Response to comment on amt-2023-89 by Anonymous Referee #2

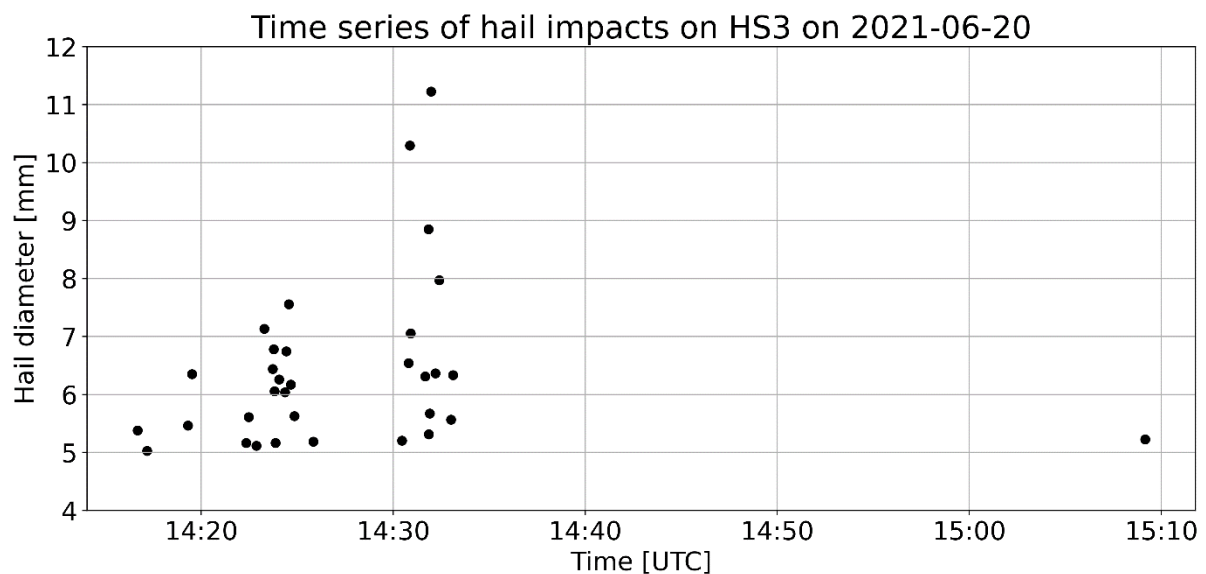
line 363-364: Can you use the time series information from these disdrometers to separate the two hail events for HS3?

After looking at the time series of impacts for HS3 below (no disdrometer data), the single impact near 15:10 was discarded as it happened 40 minutes after the event and could result from a non-hail object.

All others impacts were considered to be part of the same event as they were separated by less than 5 minutes each, strongly indicating that they belonged to the same cell (Ref: How observations from automatic hail sensors in Switzerland shed light on local hailfall duration and compare with hailpad measurements, Kopp et al. 2023).

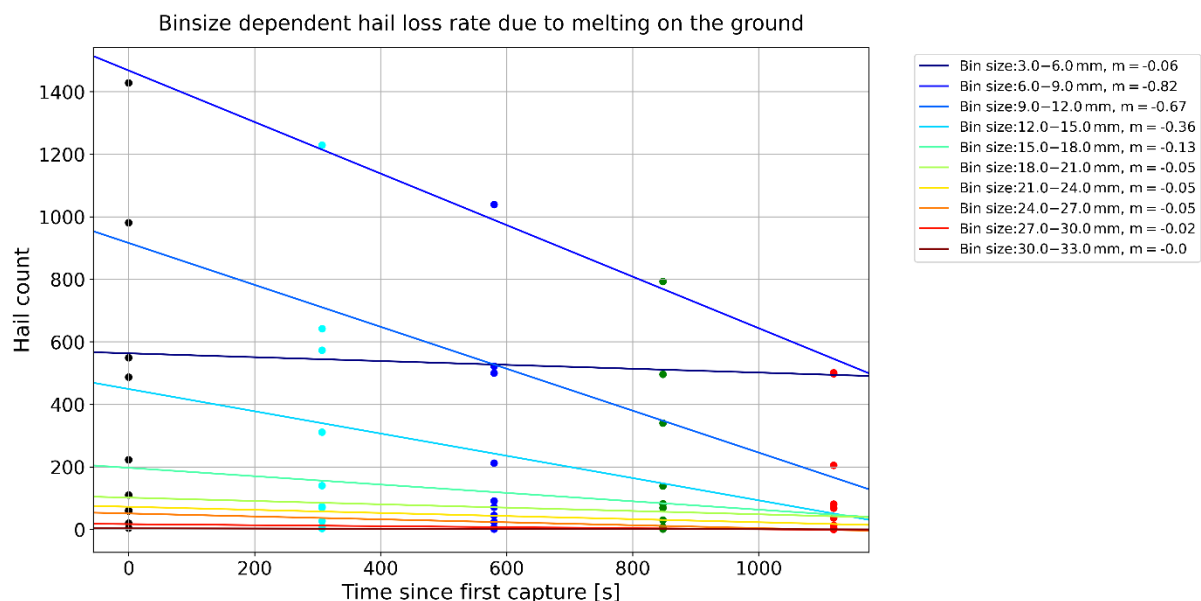
lines 385: I feel a more effective plot for the analysis of melting rates would be to use initial size bins, fit a linear fit to each size bin and plot the slope. This would directly show the melting rate for different sizes.

Your explanation for a more effective plot of the melting rate is not totally clear to us and we encourage you to explain it a bit more detailed. At least we tried to go into this direction somehow and therefore want to present a plot here in our answer, but we are not sure if this is what you really meant.

In this plot we show hail counts versus time since first capture for a series of bin sizes. The colored scatter points mark the 5 consecutive flights while the colored lines go with the different bins. Of course one could intuitively think that when the slope of these lines is higher, the higher is also the melting rate within this bin. But this is not necessarily true, because stones change bins and can even over jump a bin between 2 consecutive flights. It is quite obvious in the first bin (3-6mm), which gets steadily filled up by stones from the higher bins and we just do not know exactly from which bin these stones come. Most of them likely from the bin above.

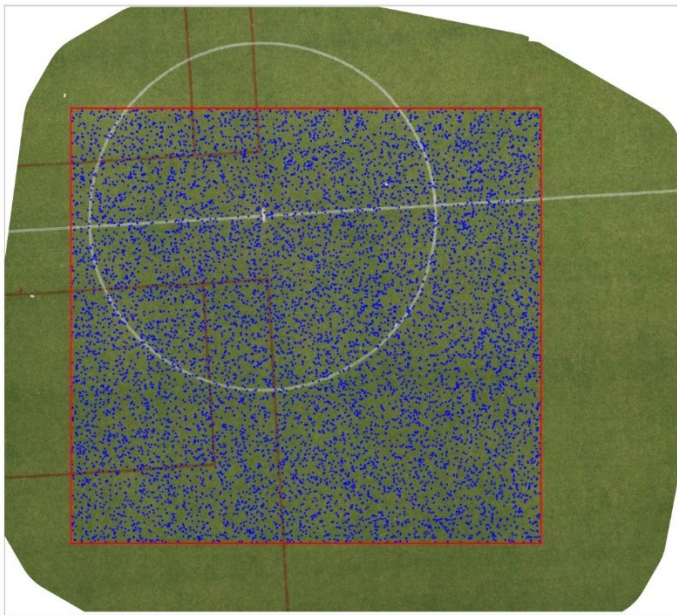
Figure 3: Please just describe colors as their proper names (e.g., dark red, light grey and green). Also, there overlap in (d) is significant and I can't really get much from it. Can you just show the center locations perhaps?

Color names were changed from "whitish" to "light grey", "greenish" to "green" and "reddish" to "dark red".

With the added alpha transparency in subplot (d) one at least see where there is a lot of overlap present as the blue gets darker. From our point of view it makes more sense to show the actual size of the virtual sensor areas with respect to the soccer field area than just the center points of the sensors. However, we also show here the plot version with the smaller center points of the

locations, for further discussion. We are up to add/exchange it at a later stage, if you still think it is worthwhile.
